PUD Area Plan / Rezoning Review For City of Dexter, Michigan

Applicant:	MMB Equities, LLC – Steve Brouwer
Project Name:	Grandview Commons
Location:	7931 Grand Street (08-06-155-001) 7905 Grand Street (08-06-427-001) Vacant Baker Road (08-06-427-002) 7961 Grand Street (08-08-06-285-004)
Current Zoning:	I-1, Limited Industrial / Village Residential / Baker Road Corridor
Plan Date:	January 27, 2016
Revised Date:	May 6, 2016
Action Requested:	Approval of Area PUD Plan. Approval of an Area Plan shall indicate acceptance of uses, building locations in the case of a PUD of eighty (80) acres or less in area, layout of streets, dwelling unit count and type, floor areas, densities, and all other elements of the area plan. Approval of the Area Plan also allows the applicant to apply for final site plan approval (Section 19.08 D. 3.).
Required Information:	There are two primary components to PUD Area Plan approval. The first is a review and analysis of the “Impact Assessment” as described in Section 19.08 A. 4. f. (2). The second component is the preliminary site plan is outlined in Section 19.08 B. 1. We will note any informational deficiencies in the body of this review.

Re: 8080 Grand St.

LANDSCAPING PLAN

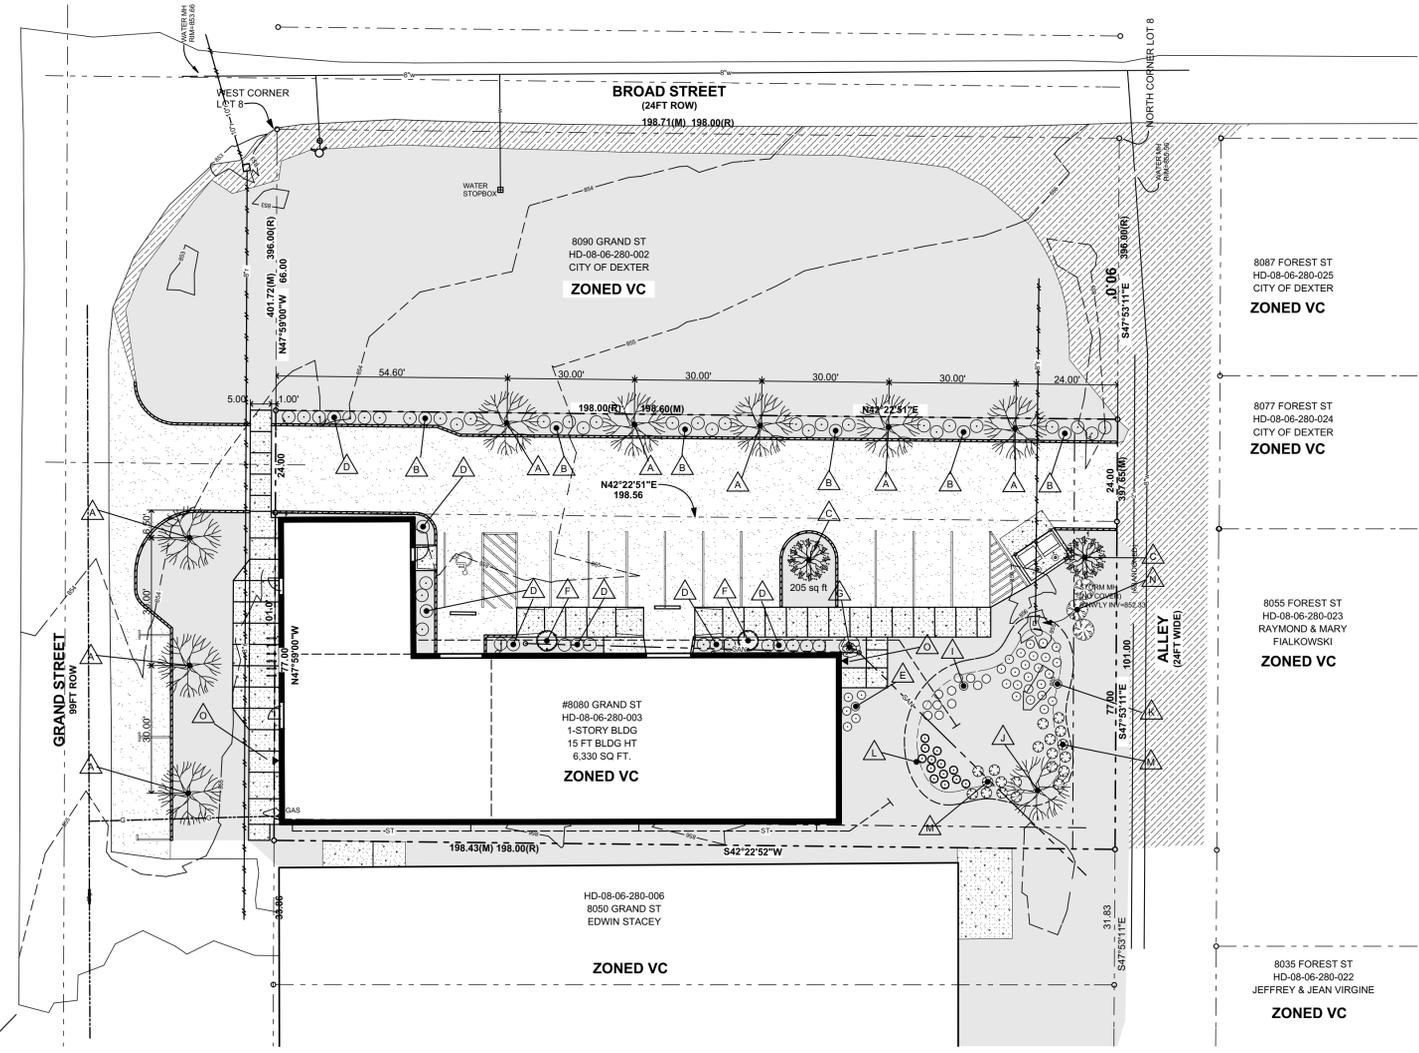
A landscape plan is provided on Sheet S-5 of the plan set.

Composition – Section 6.02A. notes *no more than 25% of any one genus or 10% of any one species per site plan*. As presented on the Planting Schedule (Sheet A1.01), the composition of the proposed plantings appears adequate.

13. The rain garden plantings listed on Sheet S-5 do not appear to be in the list of the WCWRC Rules. Information on the plantings shall be provided to ensure they are able to tolerate saturated spring conditions and dry summer conditions.

SHEET S6

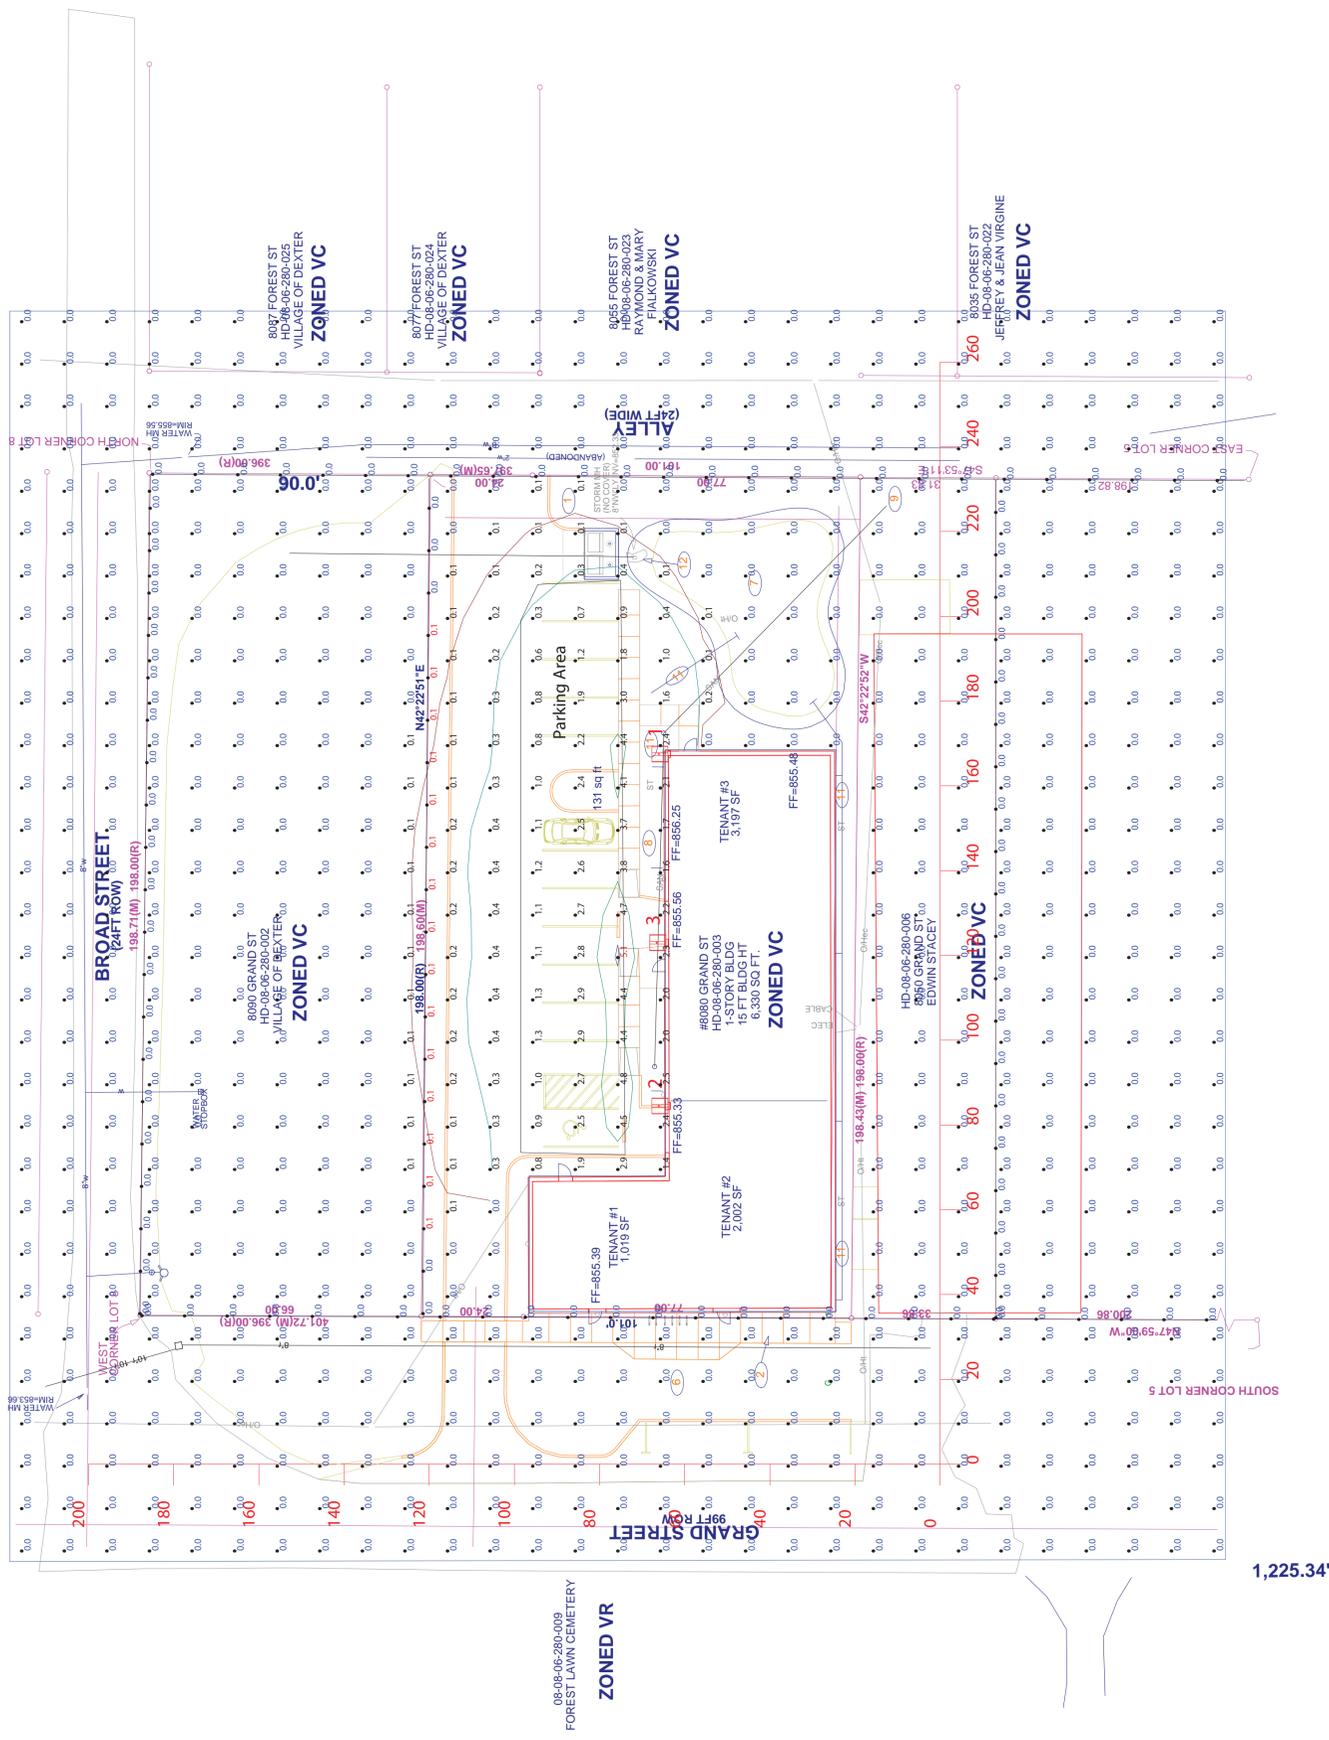
Based on the information provided, three (3) wall-mounted light fixtures are proposed along the west building elevation. Sheet S-6 demonstrates lighting levels of 0.0 foot-candles along Grand Street (south elevation) and east building elevation. A foot-candle reading of 0.1 foot-candles is demonstrated along the along the north and west property lines meeting the standards outlined in Section 3.19.

S7

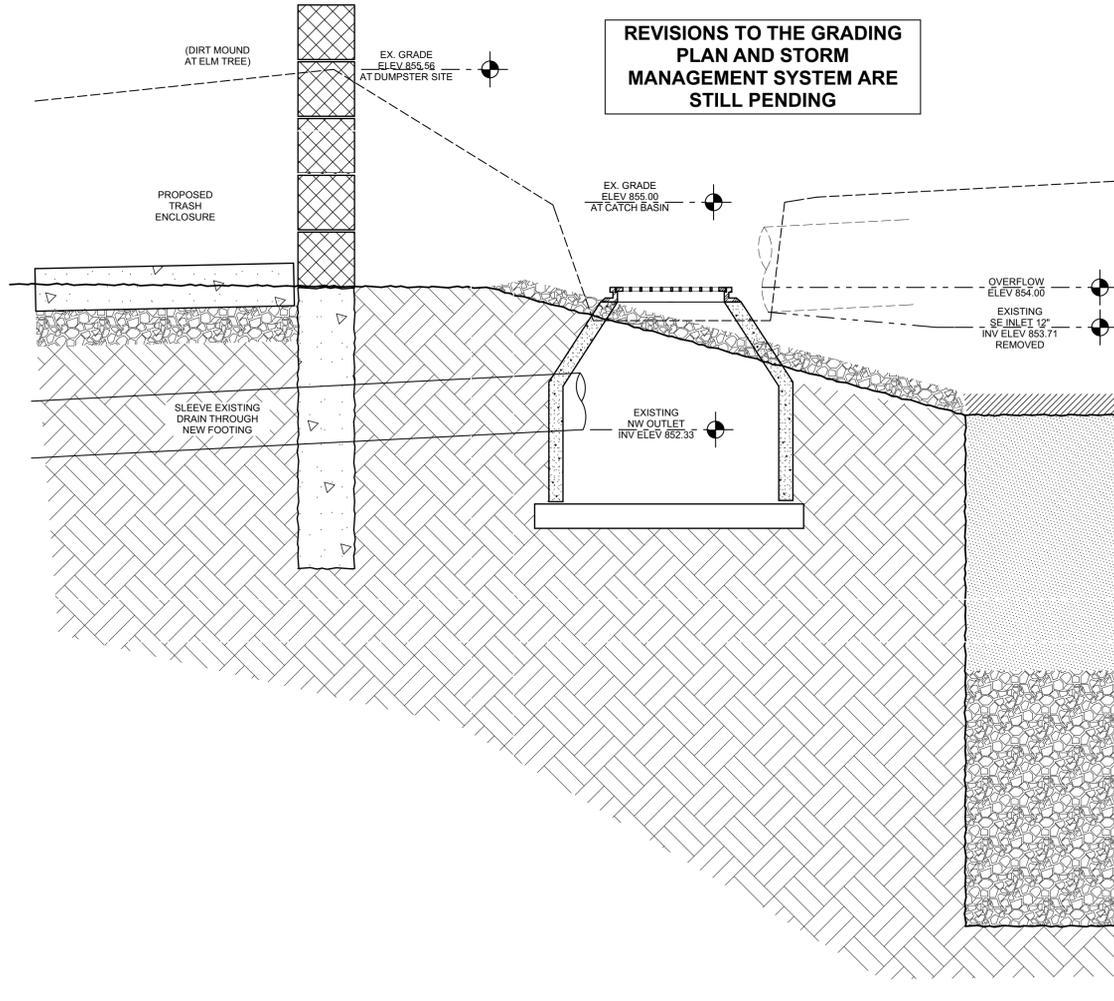
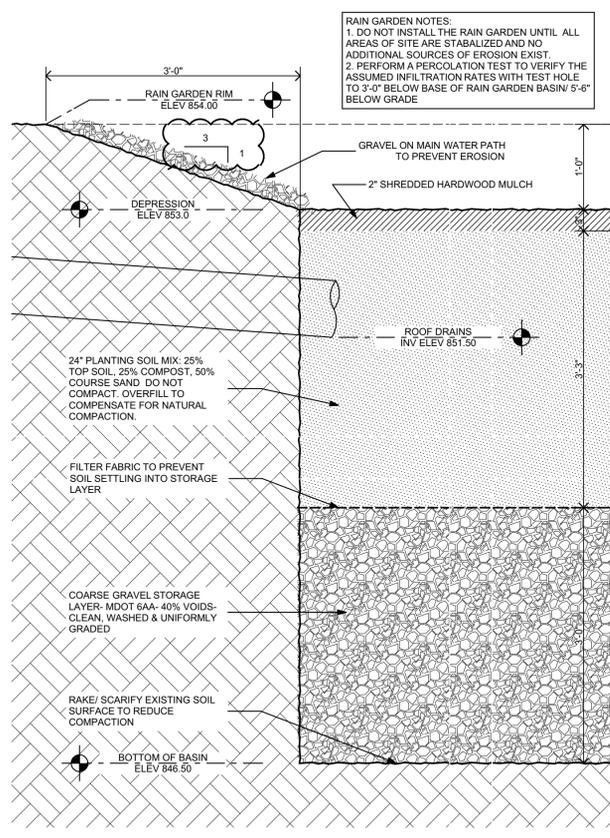
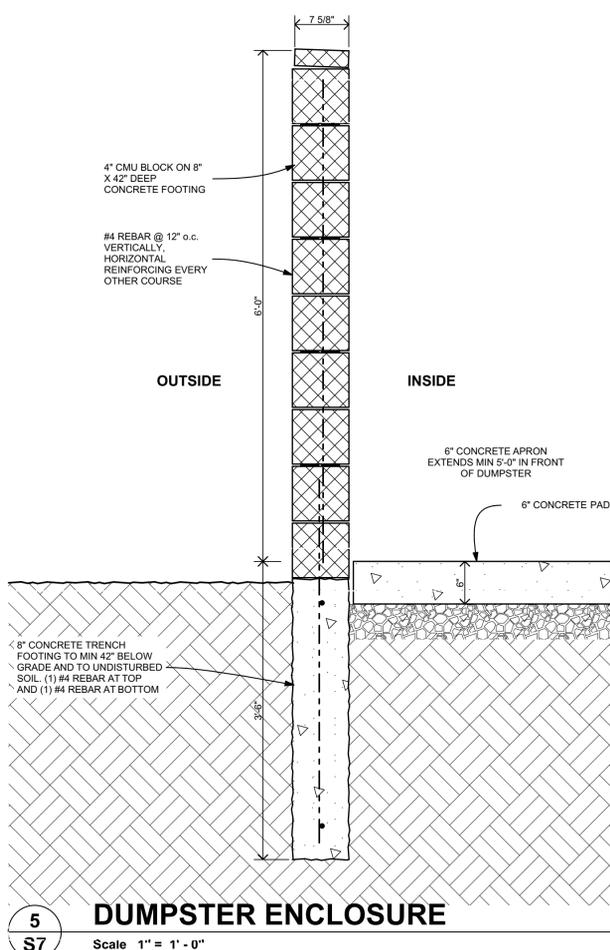
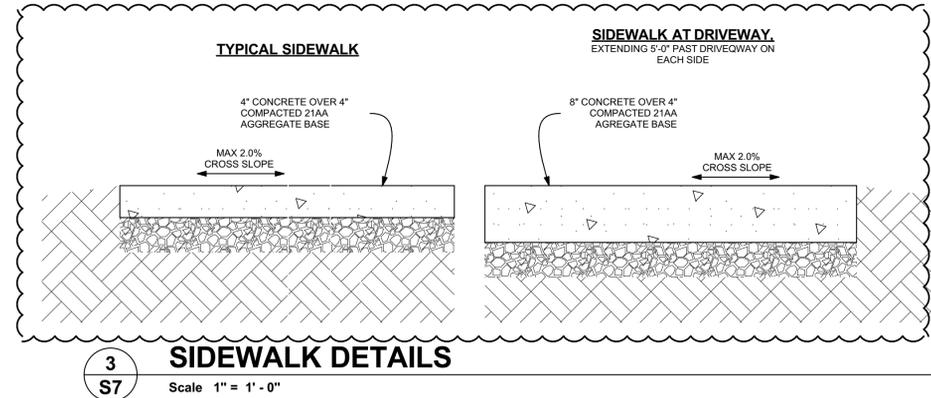
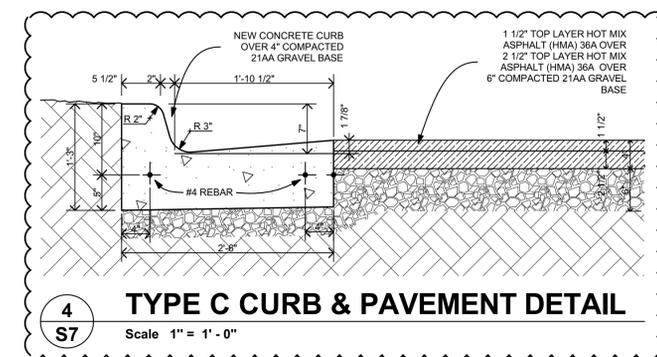
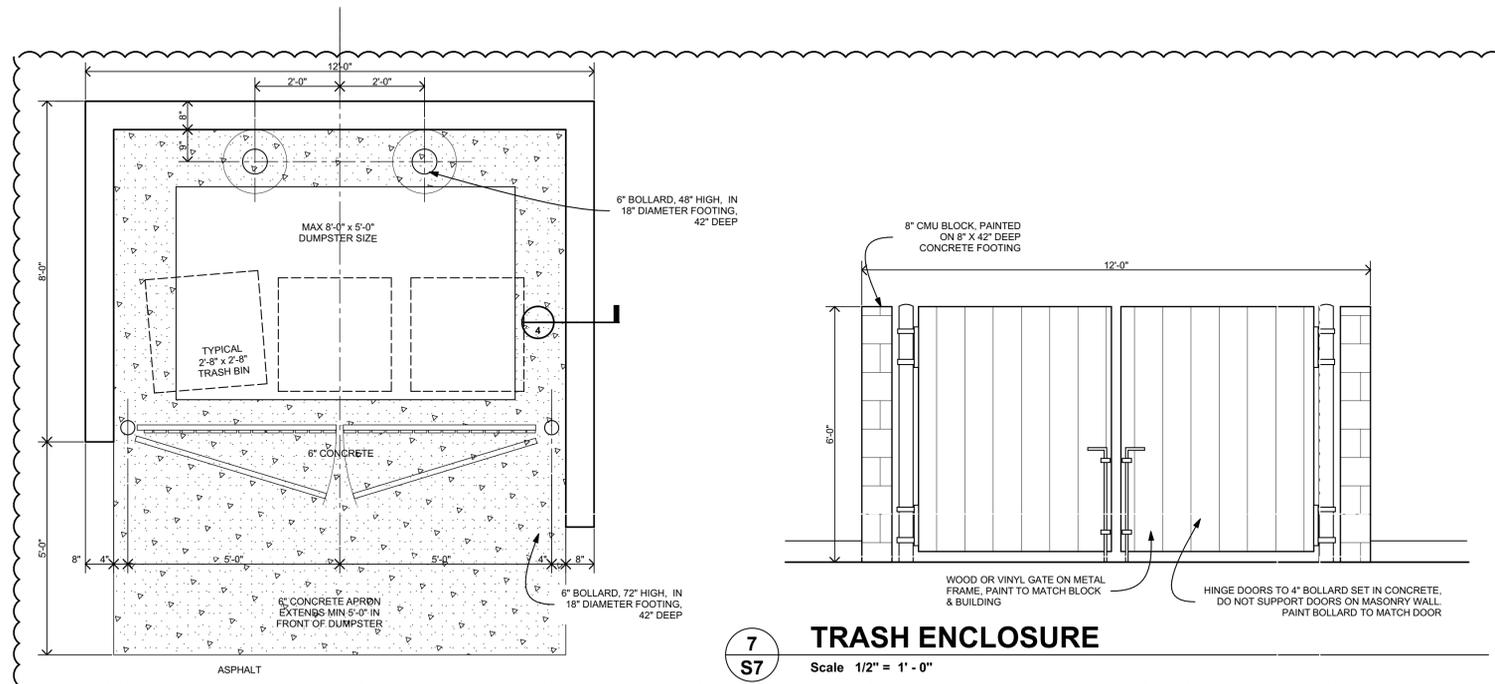
Waste Receptacle – The dumpster is located at the northeast end of the proposed parking lot. Detail of the proposed dumpster enclosure is provided on Sheet S-7. The dumpster enclosure is a masonry enclosure with wood or vinyl gate. As noted previously, trash will be moved to the curb for pick-up.

Further, Section 3.19 E. 3. Requires all fixtures to have full cutoff shades with the light source recessed into the fixture so as not be of visible from off site. As provided, the proposed fixture (detail on Sheet S7) is fully-shielded.
